APPLICATION NO.	FILING DATE	FIRST NAMED INVENTOR	ATTORNEY DOCKET NO.	CONFIRMATION NO.
10/788,788	02/26/2004	Michel Grandjean	040215-000000US	6142
20350	7590	12/08/2005	EXAMINER	
TOWNSEND AND TOWNSEND AND CREW, LLP TWO EMBARCADERO CENTER EIGHTH FLOOR SAN FRANCISCO, CA 94111-3834			COOLEY, CHARLES E	
			ART UNIT	PAPER NUMBER
			1723

Office Action Summary	Application No. 10/788,788	Applicant(s) GRANDJEAN, MICHEL	
	Examiner Charles E. Cooley	Art Unit 1723

NON-FINAL OFFICE ACTION

EP 1 050 335 A1

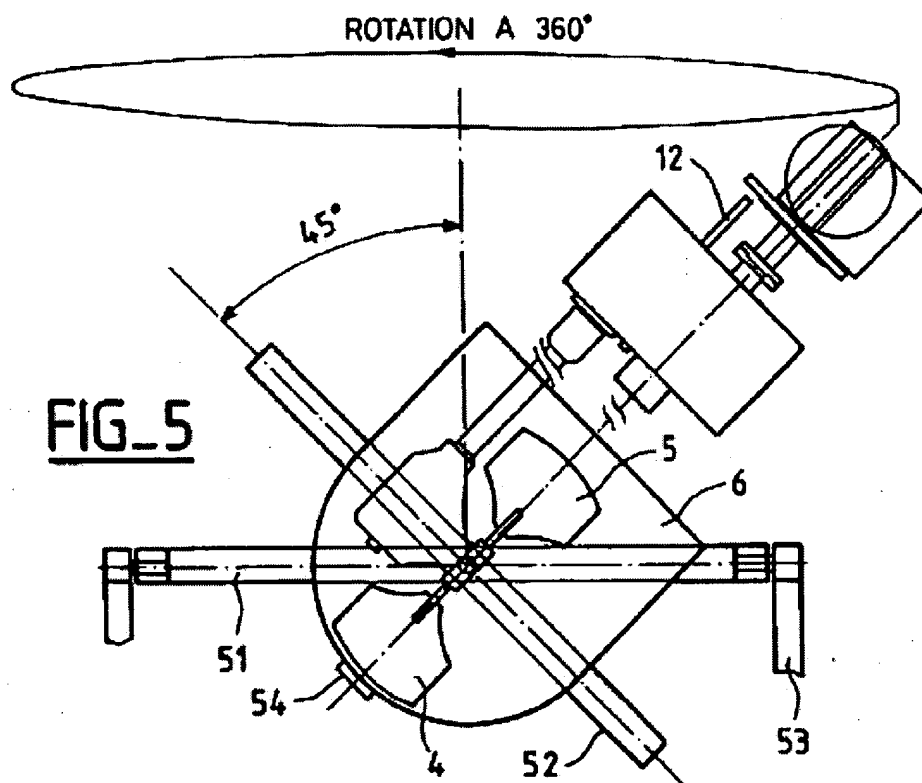
EP 1050335 A1 clearly discloses the recited mixer in Figs. 5 and 6 below and note the attached abstract describing the claimed subject matter. Fig. 5 immediately below shows the subject matter of claim 20 (the cradle arrangement).
